RE: Strategic Infrastructure Development (SID) Application

- **ACP Case Reference:** PAX03.324270
- **Development:** Slieveacurry Wind Farm (9 Turbines & Substation Extension)
- **Location:** Glendine North, Knockalassa, Tooreen, Fahanlunaghta More, Co. Clare
- **Observers:** Brian and Jenny McDowell
- **Address:** Fahanlunaghtamore, Miltown Malbay, Co. Clare, V95 X3X2

Peer Review of Proposed Slieveacurry Wind Farm Planning Application (PAX03.324270)

Figure 2

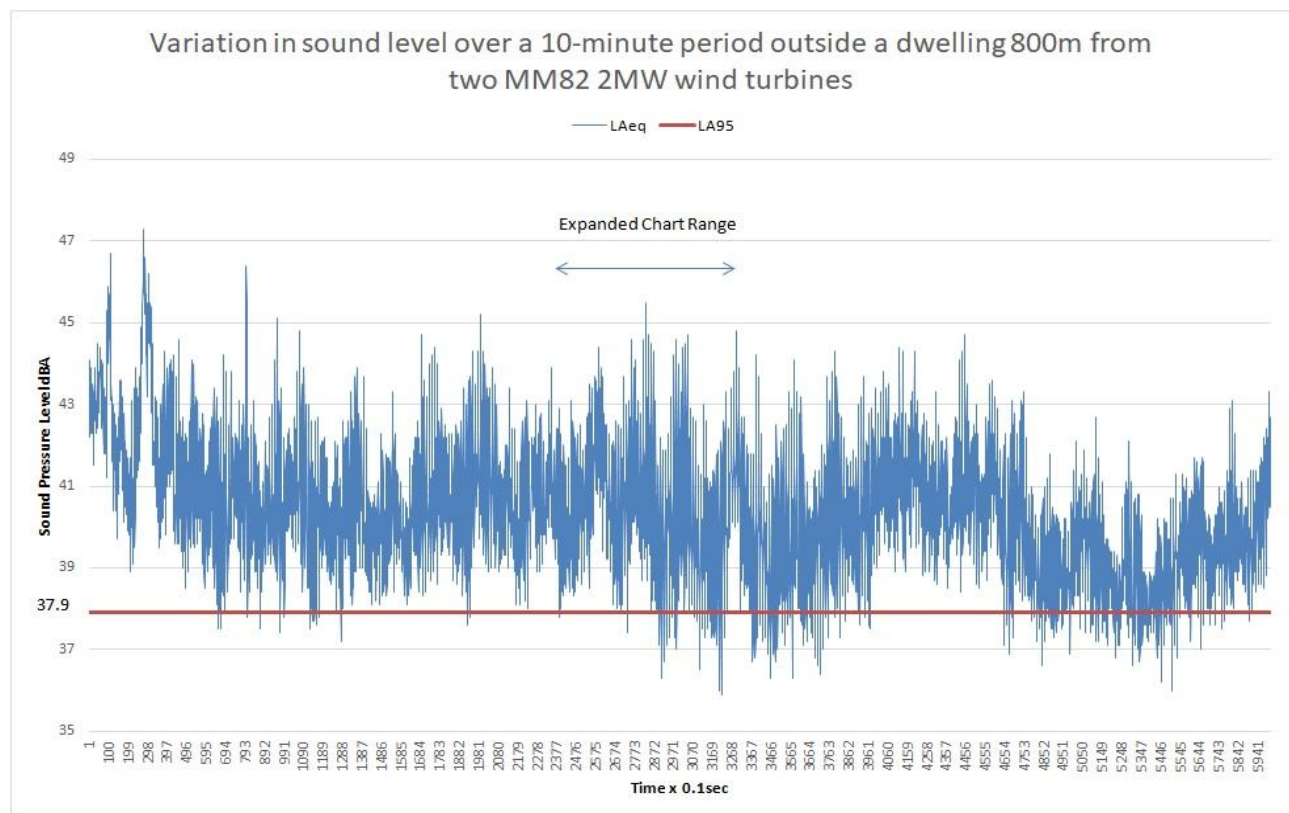
Figure 2 shows the 100ms ‘short’ LAeq values and a single LA95,10min level for the data.

Figure 2 shows the interacting effect for two wind turbines where the first part of the 10-second chart shows the turbines to be out of synchronisation with a generally lower sound level variation peak to trough compared to later in the chart where the turbine blade rotations synchronise causing higher overall peak to trough sound level changes.

An unfortunate disadvantage in using the L90 statistic is that the character of sound level changes during any 10-minute measurement are lost and sound level variations are greatly underestimated.

Figure 3

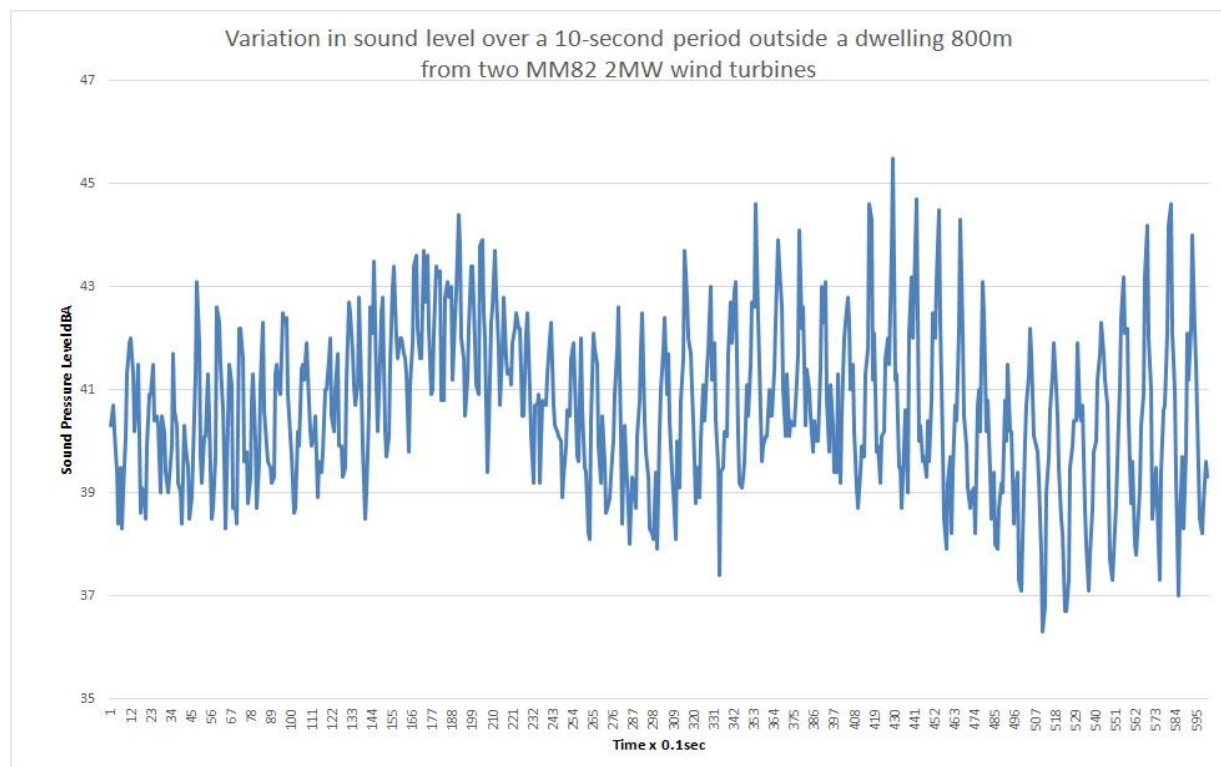
An expanded range from Figure 2 is shown in Figure 3 to provide more detail.

Figure 4

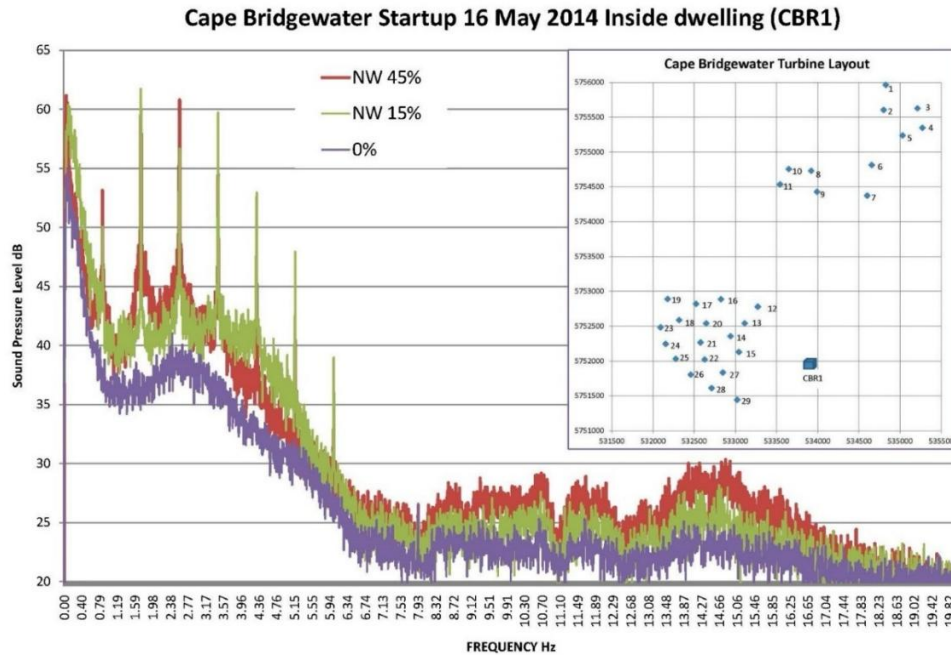
Figure 4 shows the change in infrasound levels near to the Cape Bridgewater wind farm measured inside a nearby stone dwelling during changes in operation from stopped to 15% and 45% power generation.

Figure 5

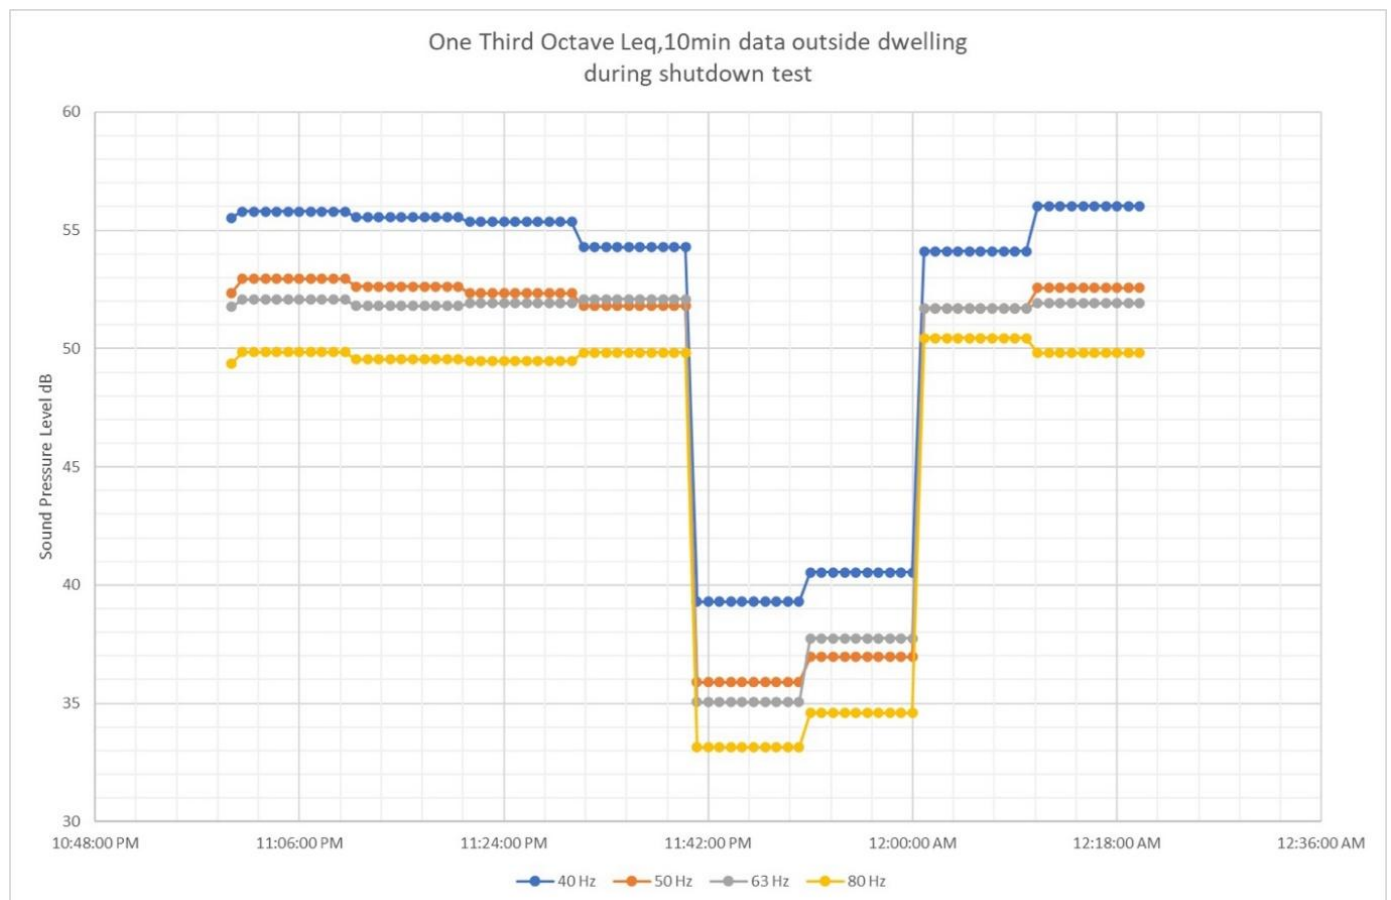
Both Colas and Buck show that wake turbulence from wind turbines spaced too close together cause increase in low frequency sound from downwind turbines.

The NVA has mistakenly dismissed ILFN as an issue.

It would be advisable to measure current ambient ILFN at the NSLs to supplement A-weighted Background survey results.
